Technical Service Bulletin

Topic	Window Drop Glass Operation Continental GT/GTC 25-26MY
Market area	Bentley: worldwide (2WBE),China 796 VW Import Comp. Ltd (Vico), Beijing (6796)
Brand	Bentley
Transaction No.	2075821/3
Level	EH
Status	Released for publishing
Release date	Jul 18, 2025

Retailer glass reset procedure for New GT/GTC

Figure 4

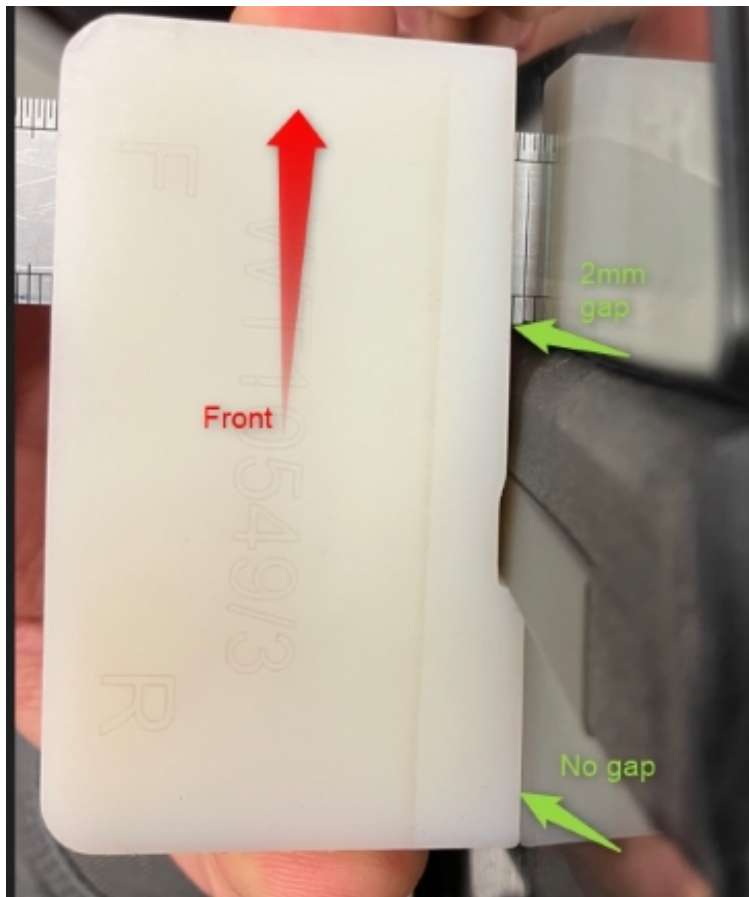
When the window is parallel take the 2mm step from the tool and minus the 2mm gap between front window and tool = -0mm (as shown in figure 4)

Figure 6

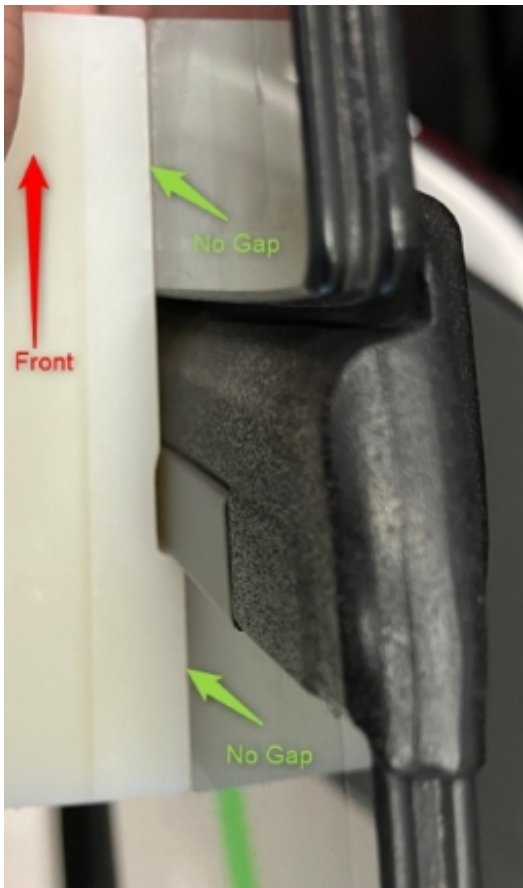
When the rear window is inboard and there is a 2mm step from the tool, when there is no gap between either window and tool (figure 6), the recorded measurement should be -2mm (figure 7)

Figure 8

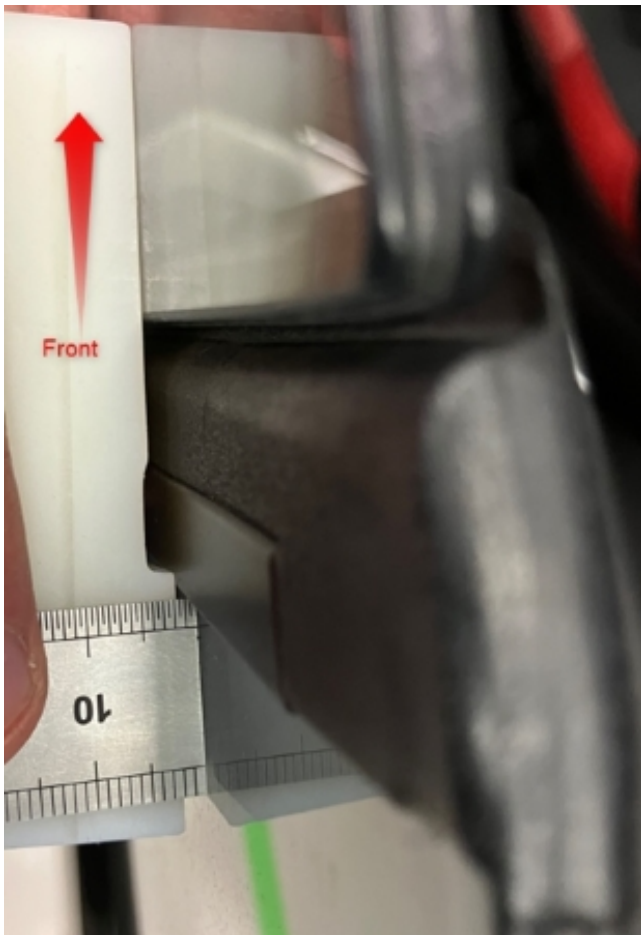
When the rear window is inboard and there is a 2mm step from the tool as well as an additional 1.5mm gap to the window (figure 8), the recorded measurement should be -3.5mm (figure 9).

Figure 10

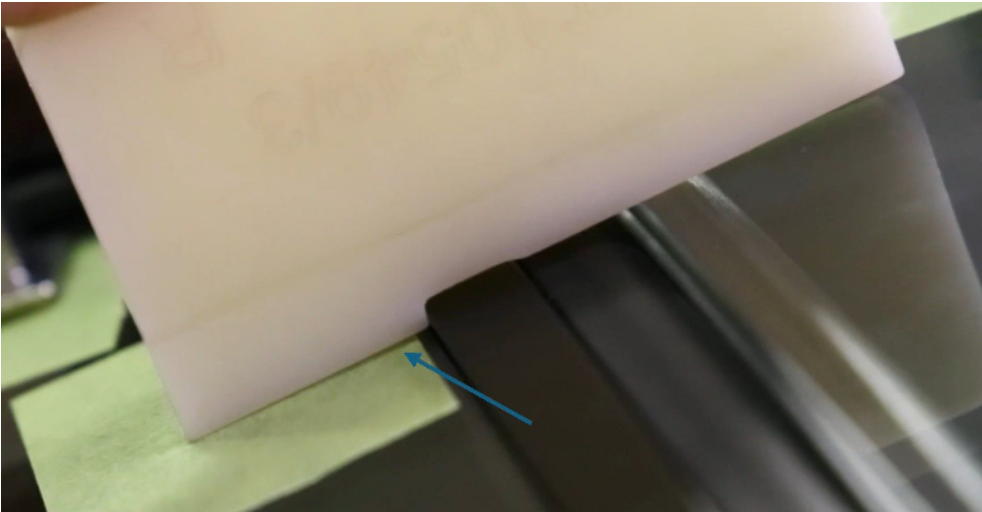
If the tool (WT10549/3) does not sit flush against the rear window then this shows rear window is more than 2mm inboard (more than -2mm), check this by holding the tool on the front window and measuring gap between the rear glass and the tool (as shown in figure 10)

- **Measuring front glass intrusion into front division bar**

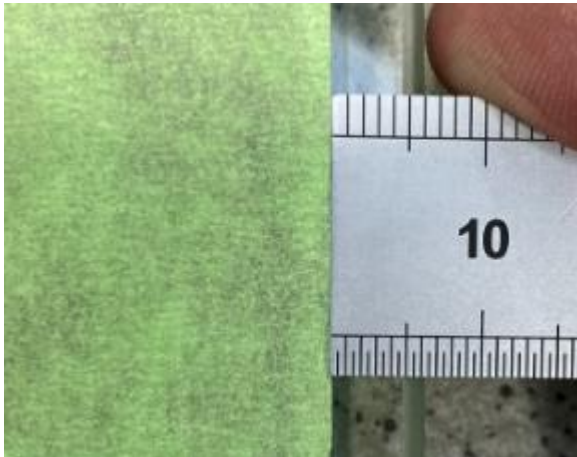
Example of incorrect fitment:
10mm intrusion into division bar seal not achieved. Only 6mm seen, front and rear side glasses will be too far rearwards, potentially clash condition between rear of rear glass and cant rail/roof seals

When reinstalling front drop glass ensure tape is applied at 10mm from front edge and align this with the previously set quarter glass division bar.

- Z Axis height adjustment on front drop glass

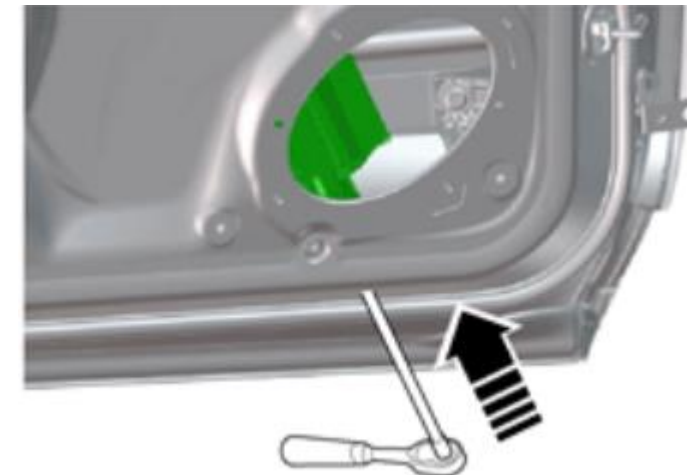
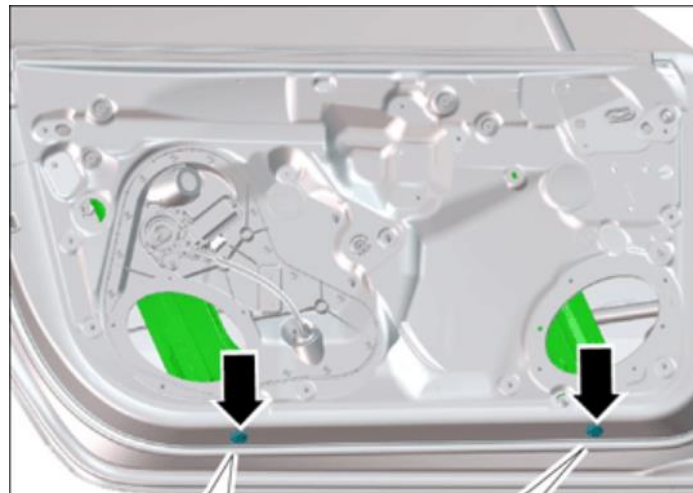
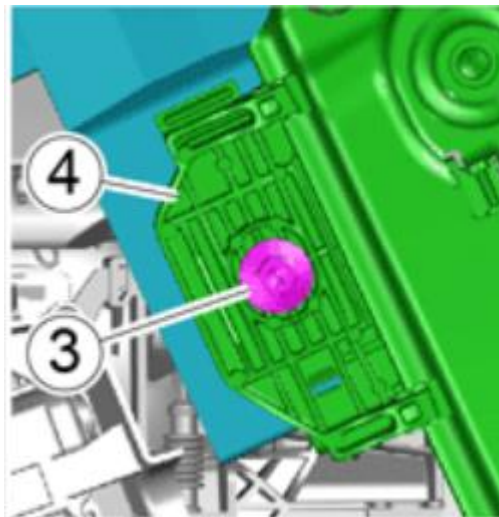
Example: Front drop glass Z axis not adjusted correctly. Bottom of tape was level with waist rail seal, after slackening pinch bolt (3 in bottom left image) front drop glass lowered 14mm to where pen marked line is.

Z-axis adjusters (bottom middle and right images) had not been used, pinch bolt had been slacked and glass lifted out of the regulator to achieve specification. This has a knock on effect of altering the 10mm division bar intrusion seen in previous slide as glass is loose and can be accidentally moved in X-axis.

This also creates a risk that the window will bottom out on the cant rail seals rather than the regulator bump stops meaning that the glass can raise further as the seals soften over time and affect end stop learning.

Z-Axis height should only be adjusted by the 4mm Allen key adjusters as per ELSAPRO

- **Waistrail measurement checking/resetting**

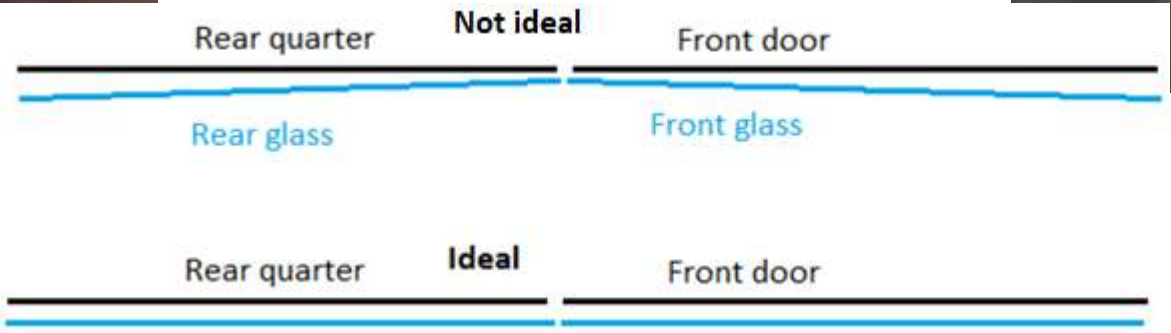
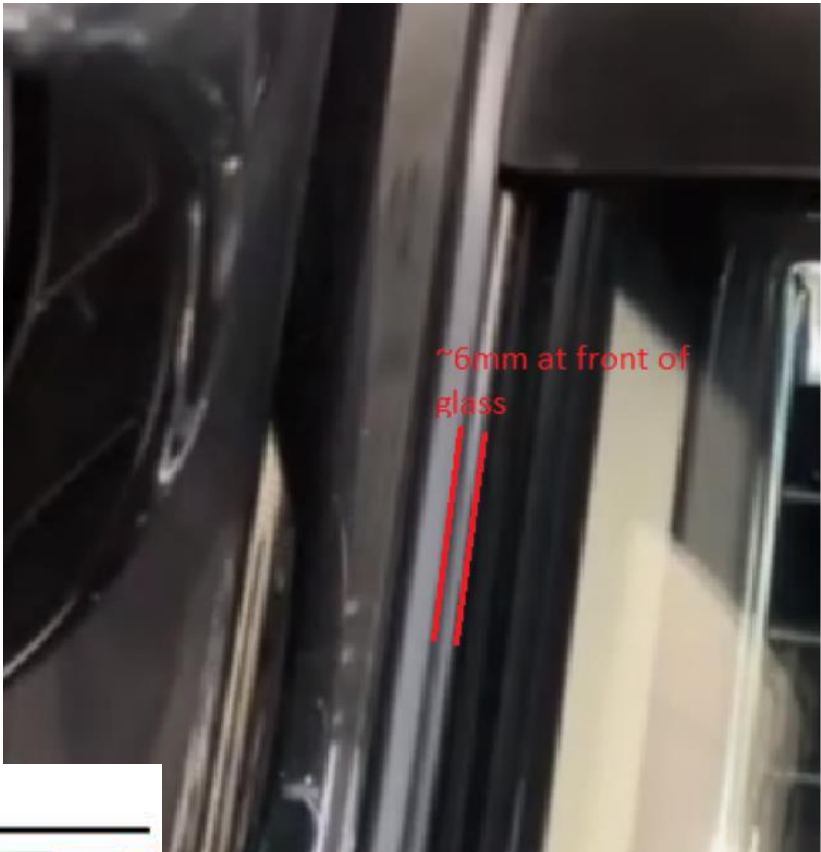
Images show a poor setting.
Circa 6mm at front edge (near wing mirror) closing up to 2mm at the rear edge.

2mm at rear edge would have been set to achieve specified flush/2mm underflush profile condition between front and rear glasses, the rear quarter glass mirrors this taper condition. This potentially increases the risk of false anti trap as rear window/seal does not engage with front window at the correct angle.

Suggested to set to specification on problem vehicles as per next slide. If both windows are set between 4-6mm then the flush/2mm underflush profile can be easily achieved.

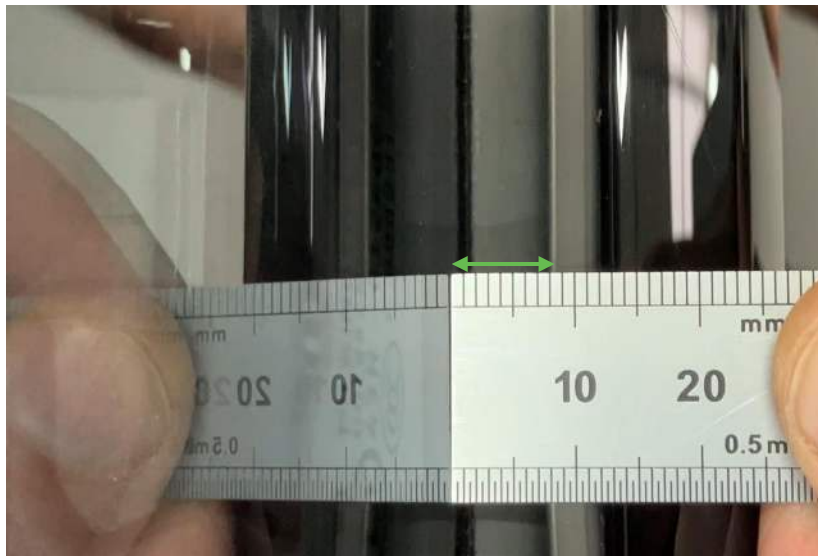
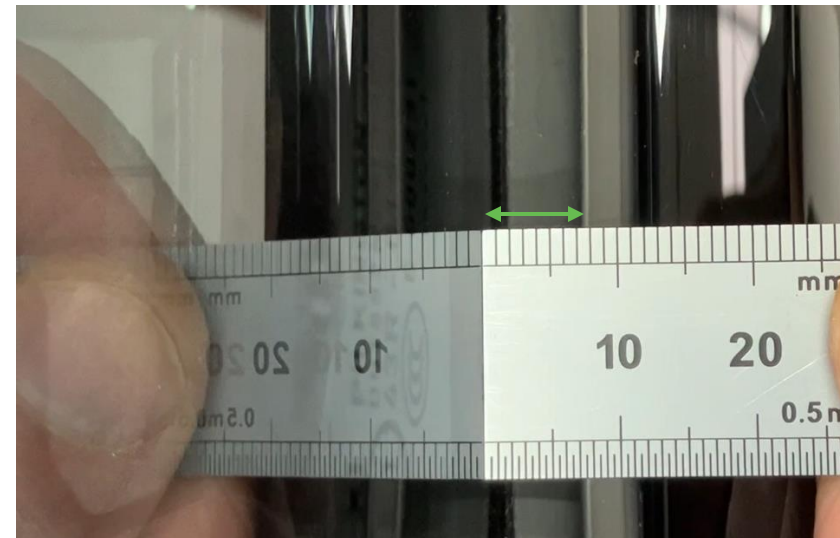
RHF window, front window closed, rear window open. Note gap

RHF window, front window closed, rear window closed. Note gap, over 0.25mm outboard movement, this is incorrect

When setting front to rear window profile and waist rail measurements ensure that the front window does not move outboard excessively when the rear window closes as this will increase current draw on the rear motor during the period where it is monitoring for it's end stop, excess current draw in this zone can cause a false anti-trap scenario.

There does need to be some tension between the front and rear glass to seal against the drop glass seal, zero mm of movement is best.

If more tension is required to resolve a wind noise or water ingress then aim for no more than 0.25mm of outboard movement.
